South Carolina Electric and Gas
V. C. Summer Nuclear Station, Units 2 & 3
COL Application

Part 4

Technical Specifications

Section A. PSTS and Bases Differences from the DCD GTS and Bases (VCS COL 16.1-1)

Figure 4.1-1 Low Population Zone Map

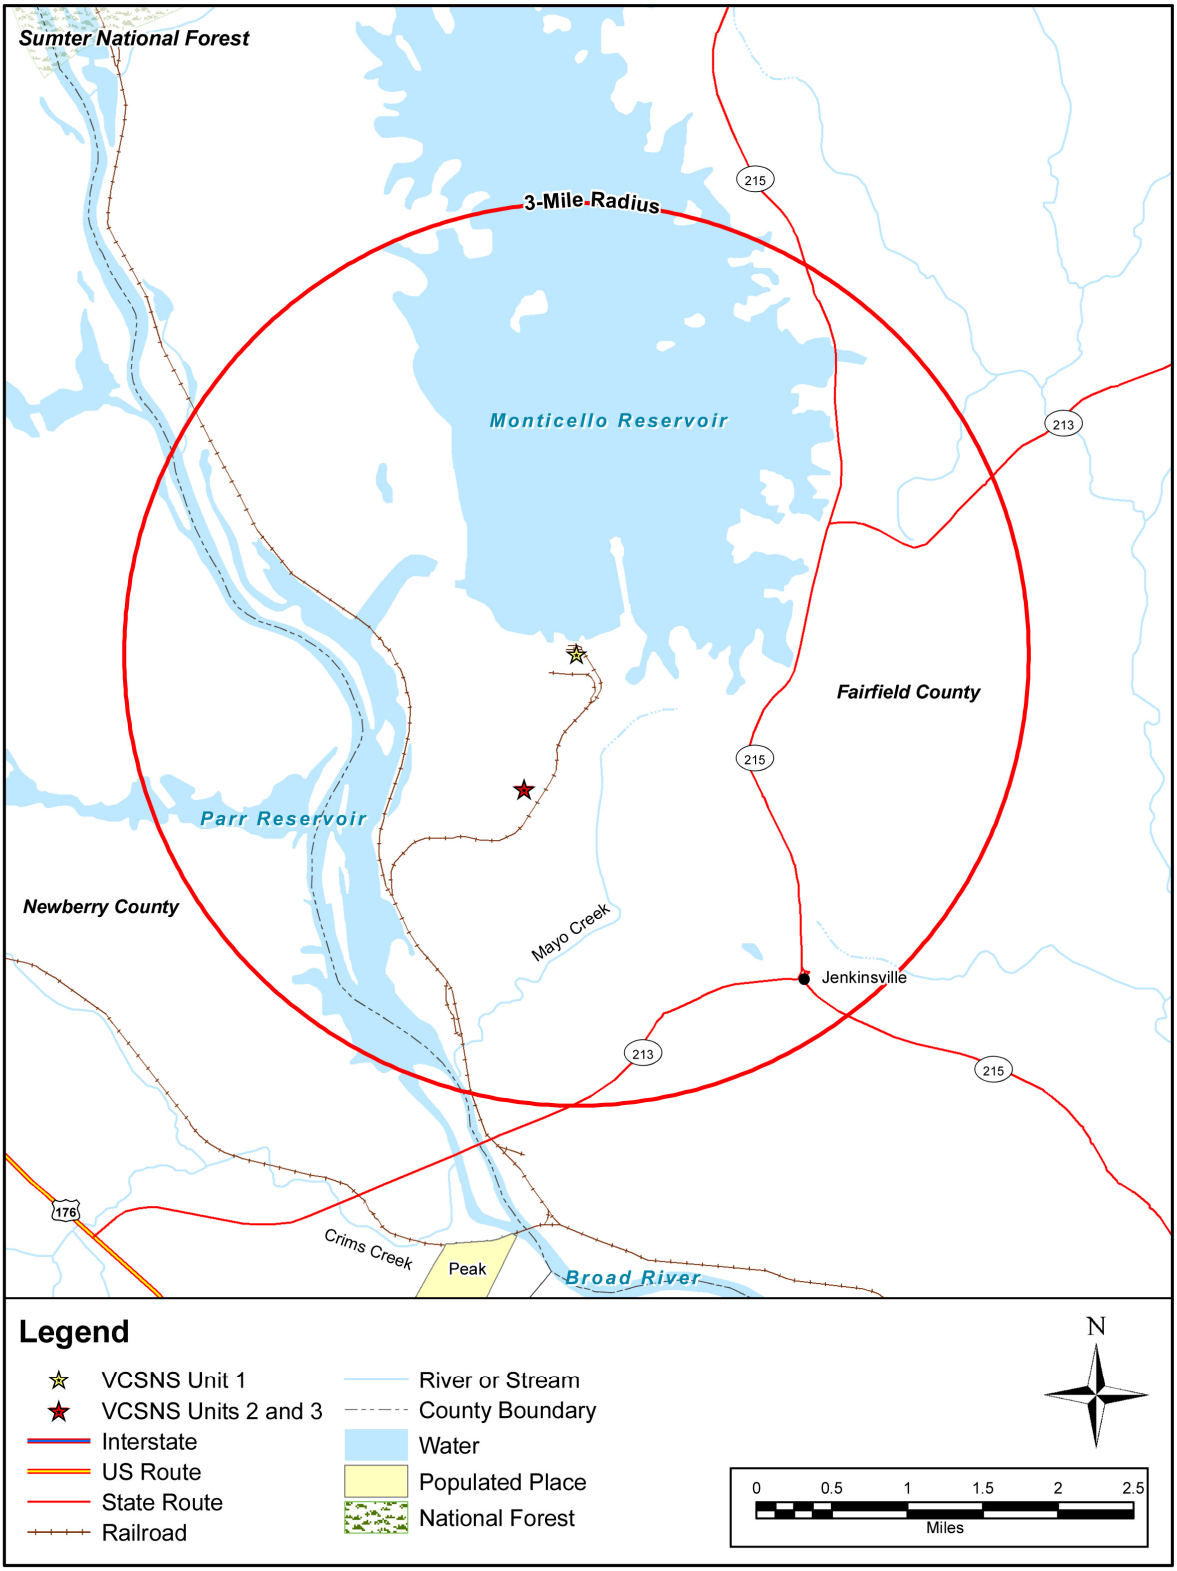
Replace the bracketed information in the GTS with the following:
The LPZ is defined by the 3 mile radius from VCSNS Unit 1 as shown in Figure 4.1-1.

Figure 4.1-2 Exclusion Area Boundary and Site Boundary Map

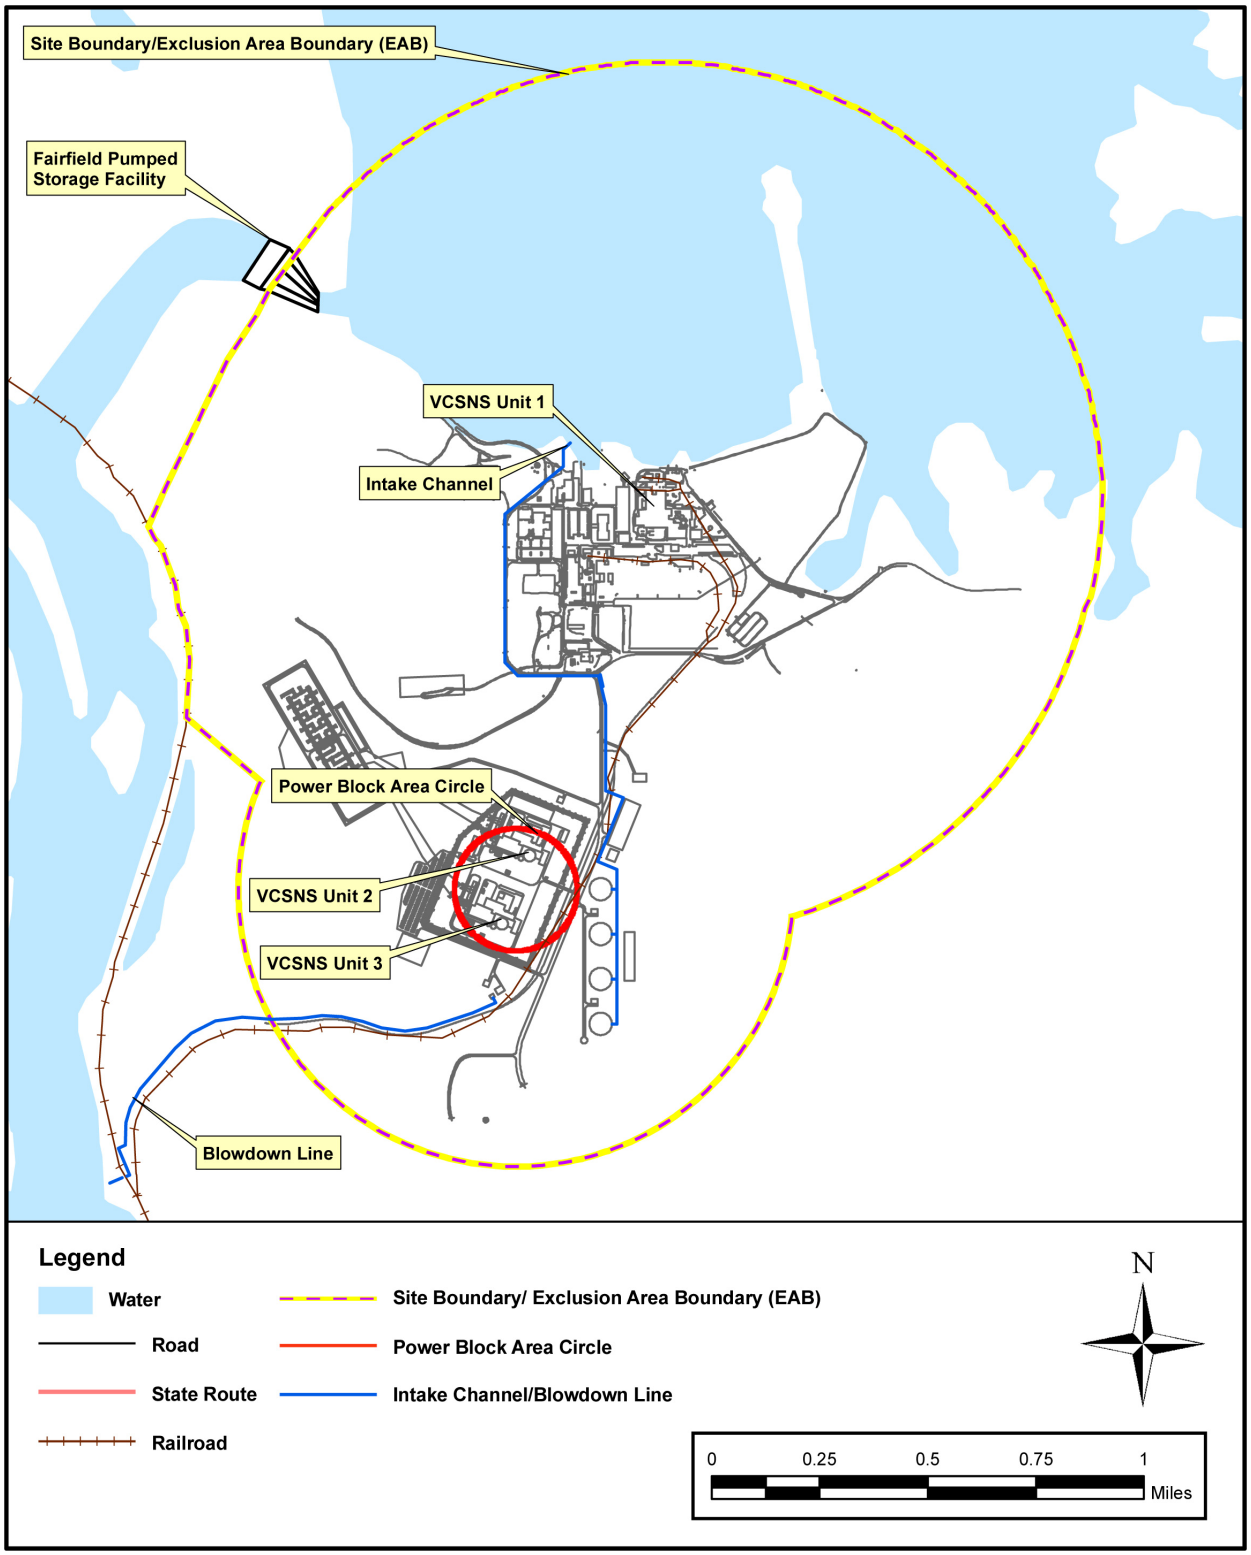
Replace the bracketed information in the GTS with the following:
The Site Boundary is shown in Figure 4.1-2. The Exclusion Area Boundary is shown in Figure 4.1-2.
